Final Environmental
Impact Statement for the

Disposal of Greater-Than-Class C
(GTCC) Low-Level Radioactive
Waste and GTCC-Like Waste
(DOE/EIS-0375)

Volume 3: Appendix J,
Comment Response Document
(Sections J.1 through J.3.1)

Figure U-25. Spatial Distribution of Groundwater Uranium-238 Concentration (Non-TC & WM Sources), Calendar Year 2135

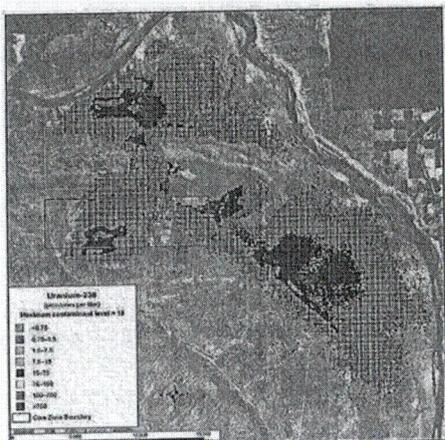
Additionally, USDOE's analysis fails to fully account for the cumulative burden of other chemical and radioactive contaminants that remain on the Hanford site, for which cleanup has thus far been unsuccessful. For example, the uranium dose for groundwater from GTCC waste presents a significant risk on its own, but it is likely to be much worse when combined with the significant uranium contamination that already exists on the Hanford site. The TC&WM DEIS predicts that uranium contamination will be a major risk to public health and the environment for thousands of years.

W539-9 Information on waste forms and waste packages and containers is provided in the EIS to allow for a comparative analysis of alternatives for transportation and waste disposal. Treatment of the wastes prior to disposal is outside the scope of the EIS. Such treatment is assumed to be addressed prior to receipt of the waste at the GTCC LLRW and GTCC-like waste disposal facility. DOE agrees that it is important to immobilize long-lived radionuclides such as Tc-99 and I-129 prior to disposal. Solidification techniques (e.g., use of grout) are expected to immobilize certain wastes in the GTCC LLRW and GTCC-like waste inventory. If needed, the actual stabilization methods used will depend, in part, on the waste stream, packaging, and final disposal facility design. DOE considers the assumptions used for waste form stability (see Appendix B) to be reasonable for purposes of the comparative analysis provided in the EIS.

Figure 6-65: Alternative Combination 2 Spatial Distribution of Cumulative Groundwater Concentration for Uranium-238 During Calendar Year 2135

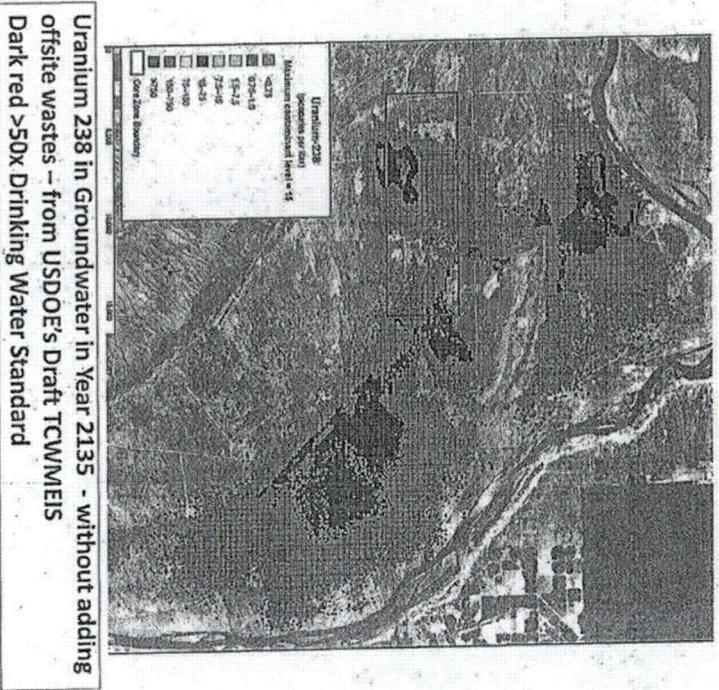
USDOE proposes to bury GTCC wastes at Hanford adjacent to the leaky unlined commercial radioactive waste dump and to the lined landfill USDOE wants to use as national radioactive waste dump for 3 million cubic feet of other offsite waste, just South of East Area High-Level Waste Tank Farms

Figure 4-6. Alternative Containment 1 Small Striped of Containment Boundary Comparison for Uranium-238 During Closure Year 3890 - Description page 4-26

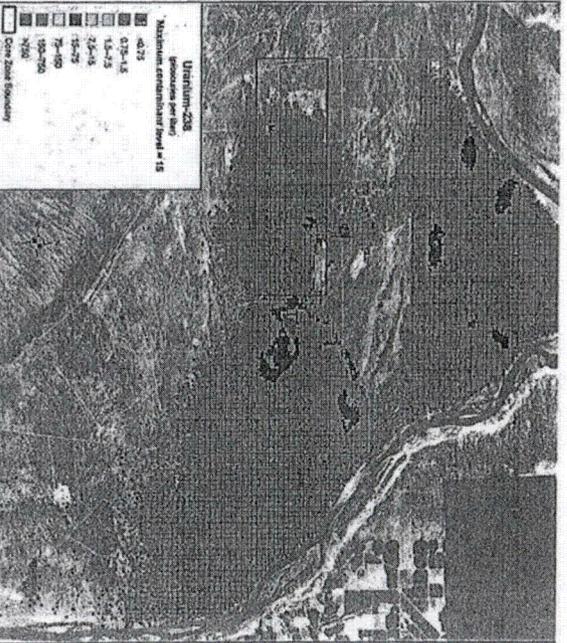
Uranium 238 in Year 3890 under Alt 2 in TCWMEIS – this contamination is without adding offsite LLW and extremely radioactive GTCC wastes. New plumes from tank leaks, residues and discharges will grow for thousands of years under USDOE’s plans to NOT cleanup tank leaks, waste discharge trenches and cribs, and to leave 1% in tanks.

FIGURE 6.2.4-2: Temporal Plot of Radiation Doses Associated with the Use of Contaminated Groundwater within 100,000 Years of Disposal for the Three Land Disposal Methods at the Hanford Site

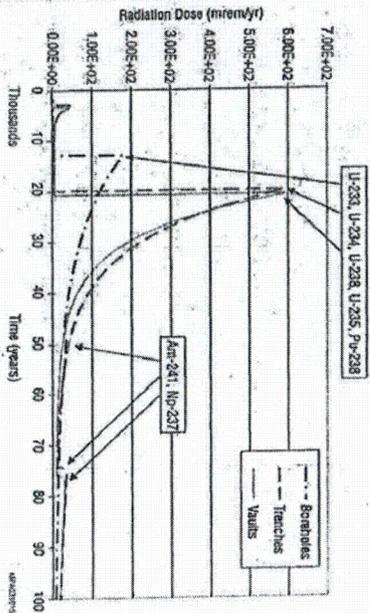
USDOE claims maximum cancer risk is "small" and shows in Summary total dose from disposal via borehole, trench or vault at Hanford is = 49 mrem per year, primarily due to Tc 99 and Iodine.

This chart shows how those claims misrepresent USDOE's own data.

Uranium, Pu and other TRU wastes will result in doses (on top of the Tc99 and Iodine) of nearly 50 mrem/year in the first 5,000 years and then reach peaks at incredibly high levels of 600 mrem per year. This 600 mrem dose should be presented as posing a risk of fatal cancer in 3.42% of exposed adult males (SEE National Research Council, National Academy of Science, June, 2005, BEIR VII at page 500, Table 12-9)

DOE has considered cumulative impacts at the Hanford Site in this GTCC EIS. The disposal of GTCC LLRW and GTCC-like waste at the Hanford Site could result in environmental impacts that may warrant mitigation for Tc-99 and I-129 through limiting receipt of these waste streams (see Table 6.2.4.2 and Figure 6.2.4.1 in this EIS).
